Re: Response to Nobis Engineering, Inc.
Phase 4 Report and Technical Memo (12/08/16)
Independent Hydrogeologic Study
100 Long Ridge Road
Carlisle, Massachusetts

Northeast Geoscience, Inc (NGI) has developed the following response to the Nobis Engineering, Inc. report and the subsequent Technical Memo, referenced above.

FIGURE A
Nitrate Dispersion Model
Concentration vs Distance at 11 ft depth or "estimated bedrock surface"

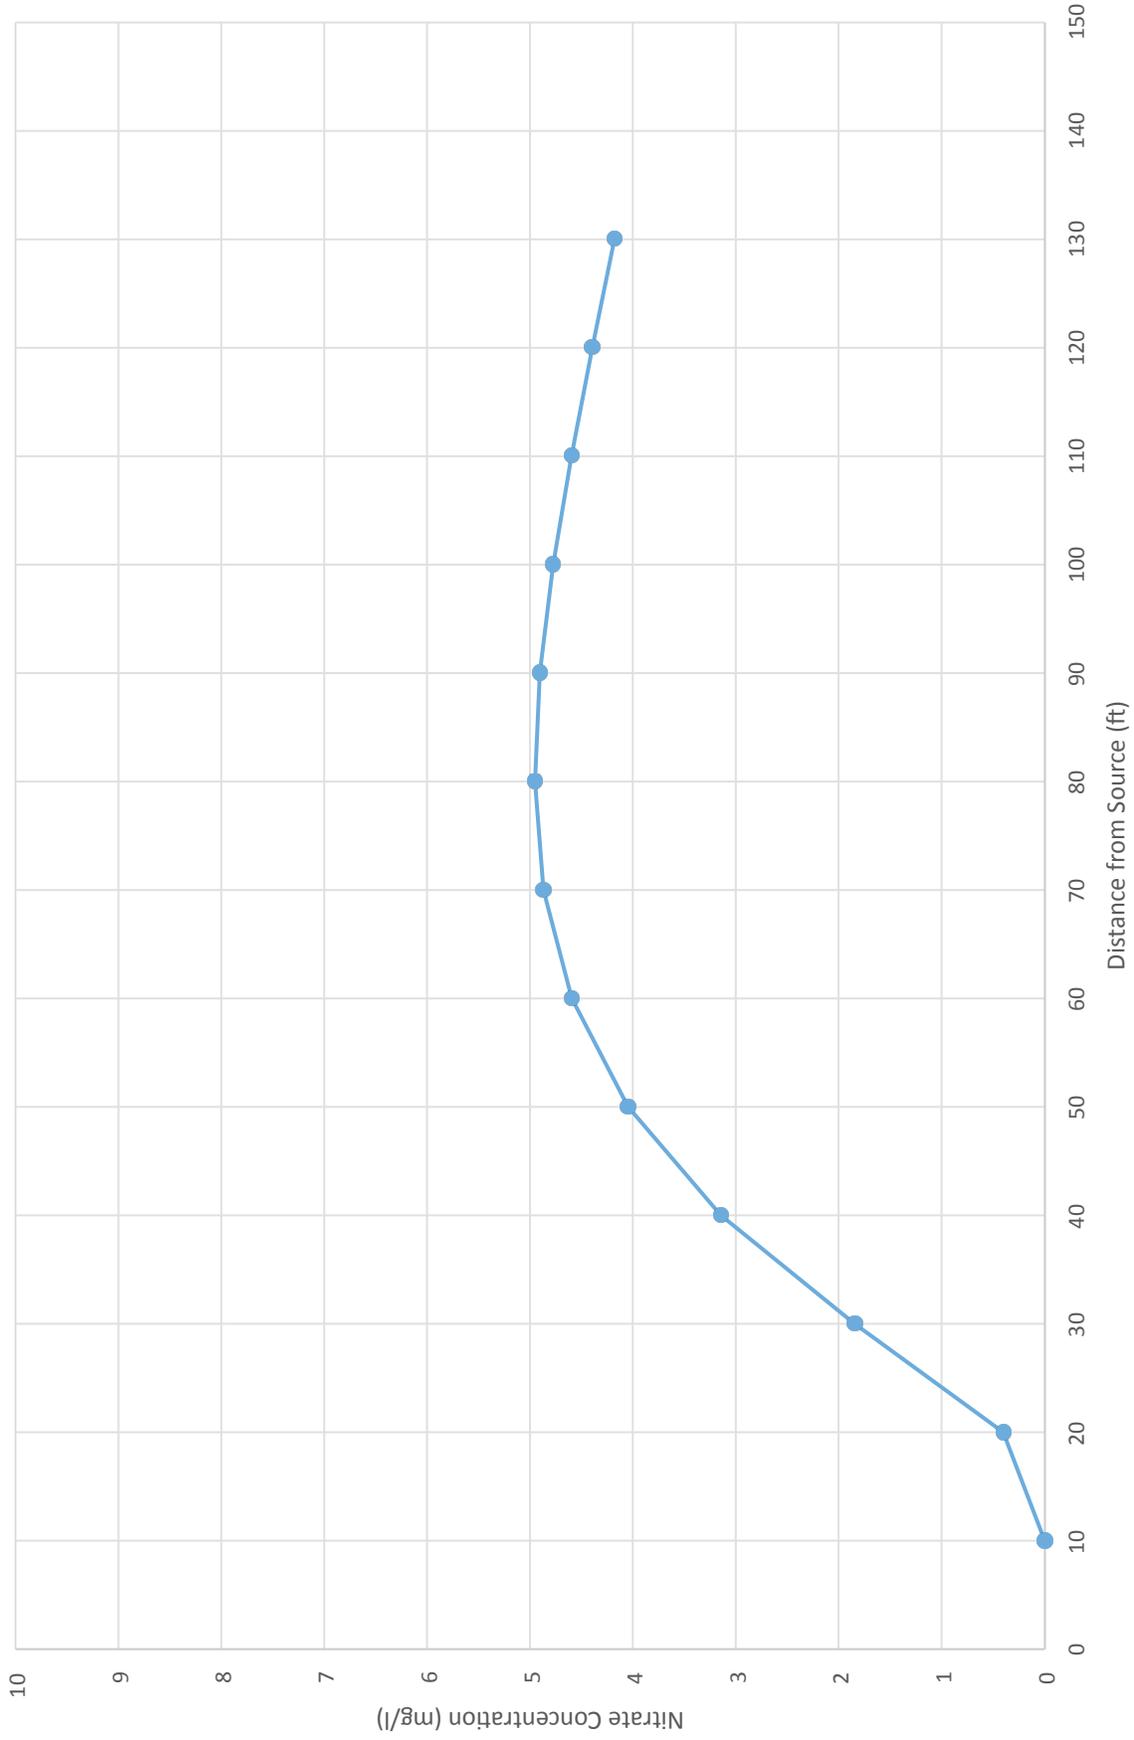
The ultimate factor in determining the potential impact to nearby sensitive receptors is the nitrate concentration distribution at the bedrock surface, since flow from the overburden to the bedrock aquifer is the main concern. The depth to bedrock at the site is equal to or greater than approximately 11 feet. Using the dispersion model, we calculated the nitrate concentration versus distance from the disposal area at a depth of 11 feet and the results are shown on Figure A. As can be seen on Figure A the projected nitrate concentration increases to a maximum of approximately 5.0 mg/l at a distance of 80 feet from the source and then decreases. Based on this analysis a bedrock fracture communicating with the overburden aquifer located at a distance of 80 feet from the disposal area could receive approximately 5.0 mg/l of nitrate, or roughly half of the maximum contaminant level for drinking water. This 5.0 mg/l would then need to be transported along a bedrock fracture that contributes water to a nearby private well. Even assuming no dilution during the travel time through the bedrock, it is unlikely that the nitrate concentration would exceed the drinking water threshold, especially given the fact that water level monitoring showed no significant influence on the overburden aquifer due to pumping of bedrock wells (as discussed below).

FIGURE 3. ANALYTICAL DISPERSION MODEL CONCENTRATIONS VERSUS LIMITS OF "AREA OF IMPACT"

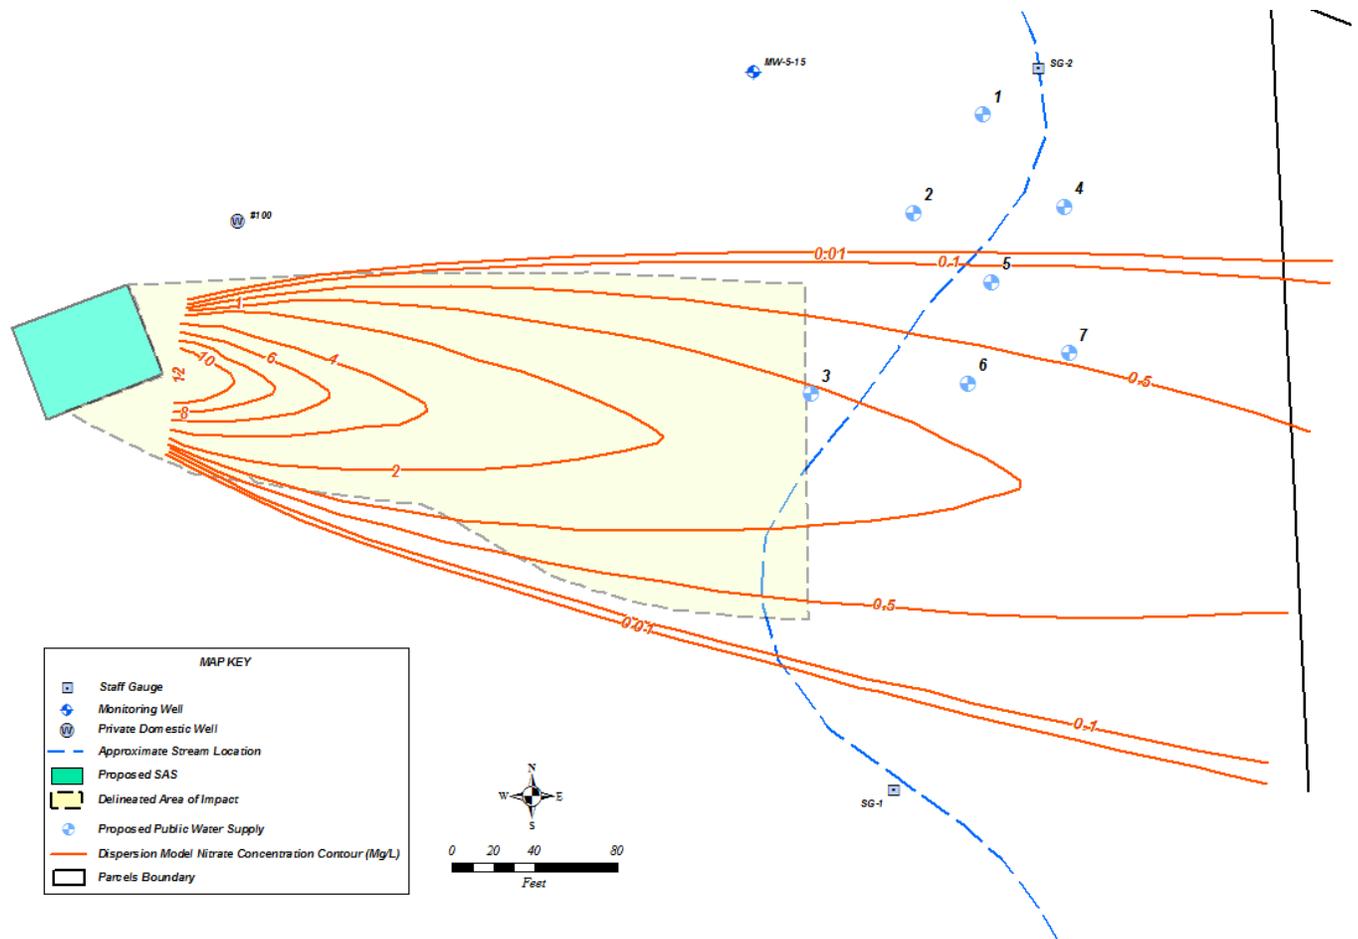
An example of the predicted nitrate Plume vs the AOI for disposal area two is included as Figure 3 - Appendix A to illustrate the dispersion and seepage velocity issues noted above. As can be seen on Figure 3, a significant portion of the projected nitrate plume exists outside of the area of impact for the reasons described above and the model projected nitrate concentrations are significantly lower than the values obtained by the mass-balance model. Figure 4 - Appendix A illustrates item 3 noted

Domenico (1987) a nitrate plume was calculated for the proposed septic system based field derived parameters and literature estimates and the results are superimposed on the AOI delineated for the site. As can be seen on Figure 2 the calculated nitrate plume for site shows solute mass outside the lateral limits of the AOI and past the downgradient limit of AOI. This figure clearly shows the effects of transverse hydrodynamic dispersion and the solute distribution when the annual groundwater transport distance exceeds the downgradient limits of the AOI. It is important to note that the nitrate concentration estimated by the dispersion model for the same point of compliance is <2 mg/l, significantly lower than the 15.4 mg/l calculated by the Title 5 Aggregation of Flows Mass-Balance Model.

FIGURE 4 - AREA OF IMPACT AS A FUNCTION OF DISPOSAL AREA ORIENTATION

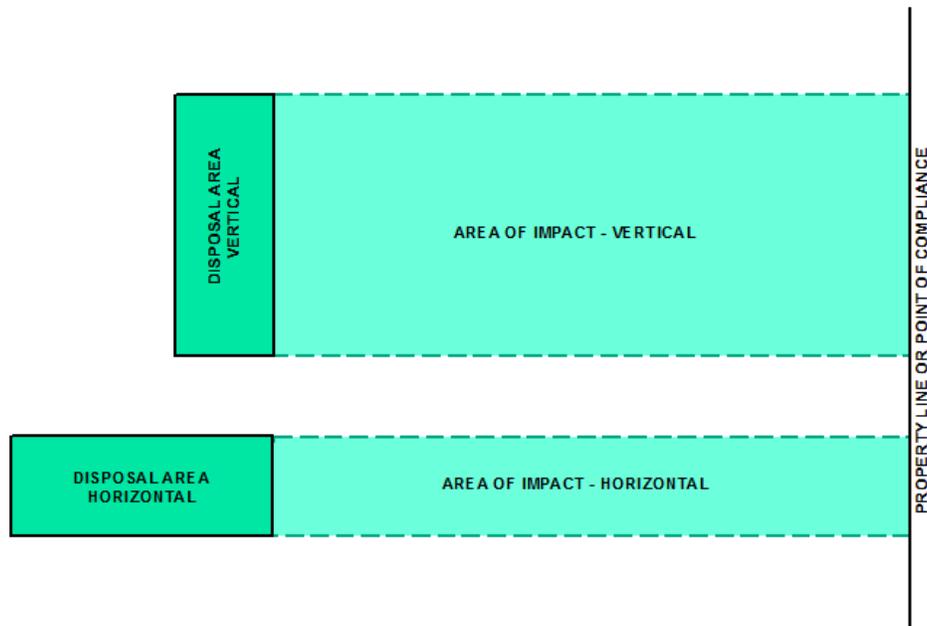
above. As can be seen on Figure 4, the AOI for the rectangular system shown, changes by more than 50% when the disposal area is rotated 90 degrees.

As can be seen on Figure 4, two different Areas of Impact result from a vertical layout versus a horizontal layout for the same disposal area. As a result the two systems, though of the same footprint and loading rate, will yield different nitrogen concentrations using the MassDEP nitrogen loading model, depending on how the disposal areas are oriented.
